Amendment C243

Hume Planning Scheme Traffic Analysis Report

Sunbury Growth Corridor Jacksons Creek Northern Bridge Removal

Prepared by: GTA Consultants (VIC) Pty Ltd for Victorian Planning Authority

Figure 4.7: LR-IN-04 Interim Intersection SIDRA Model Layout

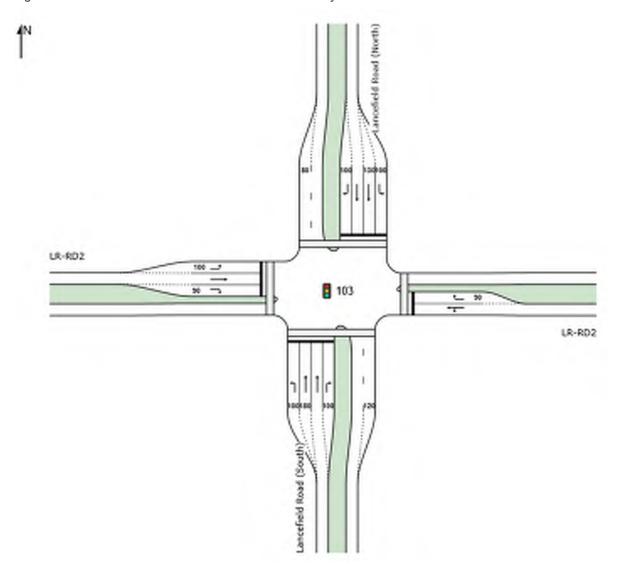
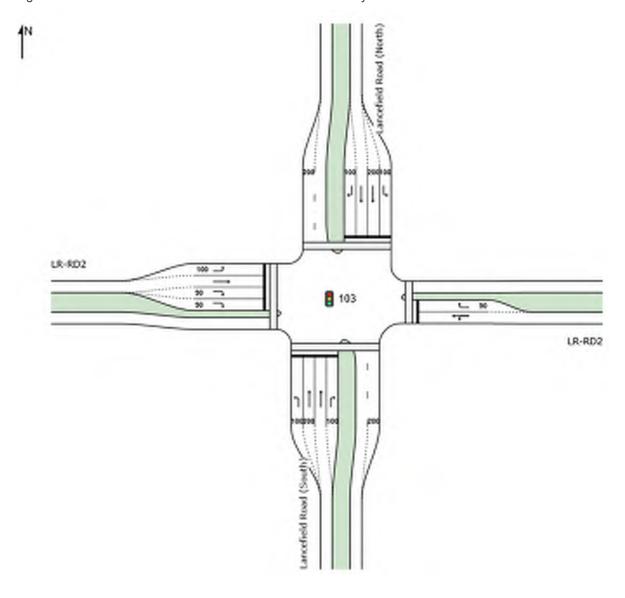
Table 4.2 shows that the interim intersection configuration for LR-IN-04 will operate satisfactorily during the AM peak with a DOS of 0.89 but marginally worse in the PM peak with a DOS of 0.95.

Specifically, it is noted that the 95th percentile queue length at the short through lane and right turn lane at the northern and southern approaches exceed the lane length.

Based on the SIDRA analysis and results, the following changes are recommended to be provided for LR-IN-04:

- 1. An additional right turn lane on the western approach (leg) of the intersection.
- 2. Lengthening the short through and downstream lanes at the northern and southern approaches to 200m.

Table 4.3 shows that the amendments to the interim intersection with the lengthening of the northern and southern short through lane and departure lanes and the inclusion of a second right turn lane at the western approach will be able operate satisfactorily with a DOS of 0.80 and 0.86 in the AM and PM peaks, respectively. Both intersections are predicted to operate with a LOS C. The delays and 95th percentile queue lengths are within acceptable limits.

Figure 4.9: LR-IN-03 Interim Intersection SIDRA Model Layout

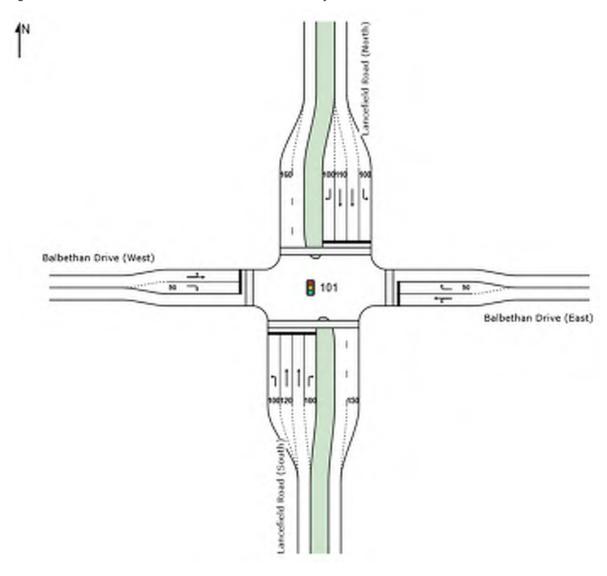
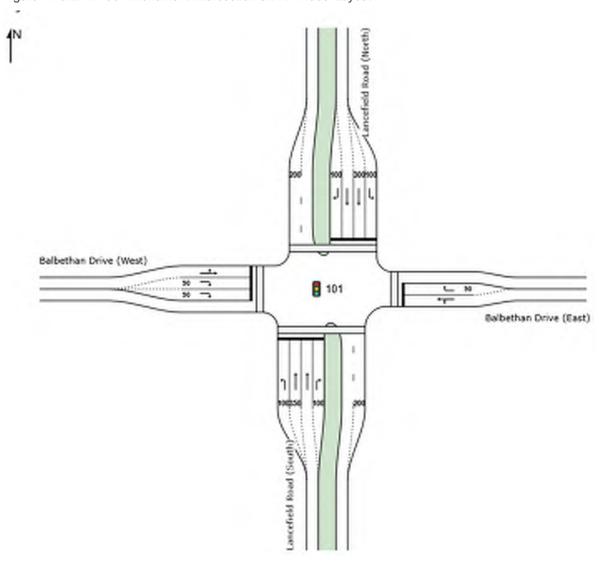
Table 4.4 shows that the interim intersection configuration for LR-IN-03 will not be able operate satisfactorily with a DOS of 1.19 and 1.22 in the AM and PM peaks, respectively.

Specifically, the DOS will be over 1, showing that vehicles will need two or more traffic signal cycles to clear the intersection during both peaks. In the AM and PM peaks, queues of over 1km long are predicted at the northern and southern approaches, respectively.

It is noted that the 95th percentile queue length for the right turn lane at the western leg during both AM and PM peaks exceeds the available lane length.

Based on the SIDRA analysis and results, the following changes are recommended to be provided for LR-IN-03:

- 1. An additional right turn lane at the western approach (leg) of the intersection
- 2. Lengthening the short downstream lanes at the northern and southern approaches to 200m
- 3. Lengthening the short through lanes at the northern approach and southern approaches to 300m and 350m, respectively.

Table 4.5 shows that the amendments to the interim intersection with the lengthening of the northern and southern short through lane and departure lanes and the inclusion of a second right turn lane at the western approach will be able operate satisfactorily with a DOS of 0.87 and a LOS of D in the AM and PM peaks. The delays and 95th percentile queue lengths are within acceptable limits.

Figure 4.11:SS-IN-03 Interim Intersection SIDRA Model Layout

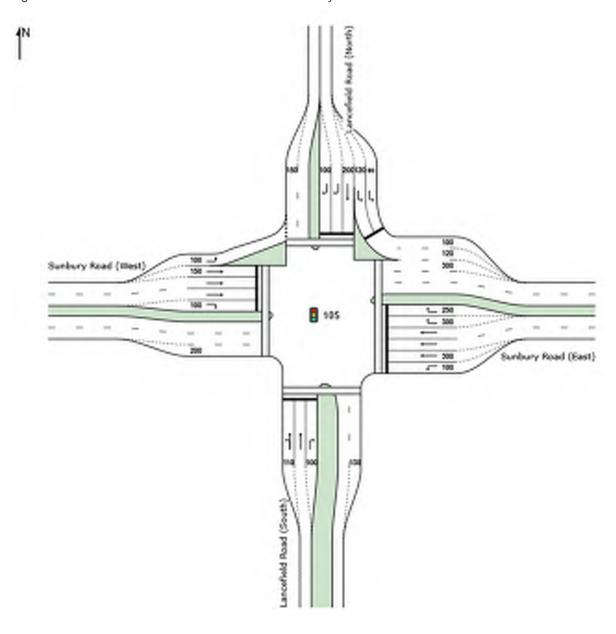
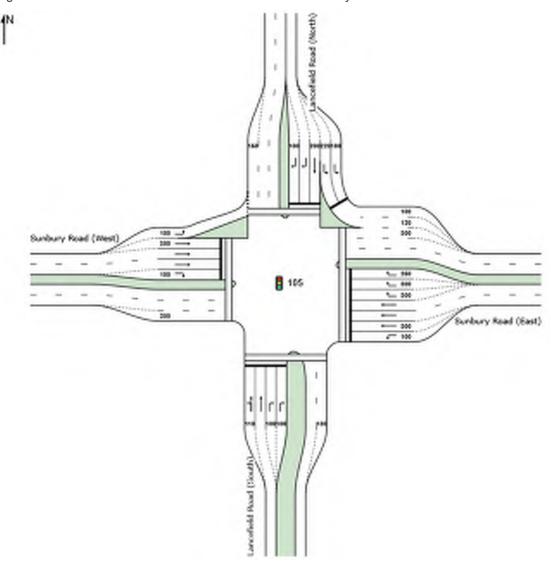
Table 4.6 shows that the existing intersection configuration (with signalised left turn slip lane from the north) will not be able to operate satisfactorily with the proposed design volumes in both peak periods.

Specifically, the DOS will be over 1, showing that vehicles will need two or more traffic signal cycles to clear the intersection during both peaks. This is particularly evidence in the PM peak, where the DOS is over 1 at the southern, eastern and western approaches. At the western approaches delays of just under four minutes are predicted for vehicles turning right from Sunbury Road onto Lancefield Drive.

Based on the SIDRA analysis and results, the following changes are recommended to be provided for SS-IN-03:

- 1. An additional right turn lane at the southern approach (leg) of the intersection.
- 2. An additional right turn lane on the eastern approach (leg) of the intersection.
- 3. Lengthening the signalised left turn slip lanes on the northern approach from 180m to 220m and from 80m to 120m.

Table 4.7 s shows that the amendments to the interim intersection with the lengthening of the northern and southern short through lane and departure lanes and the inclusion of a second right turn lane at the western approach will be able operate satisfactorily with a DOS of 0.88 and 0.89 in the AM and PM peaks, respectively. Both intersections are predicted to operate with a LOS D in the AM and PM peaks. The delays and 95th percentile queue lengths are within acceptable limits.
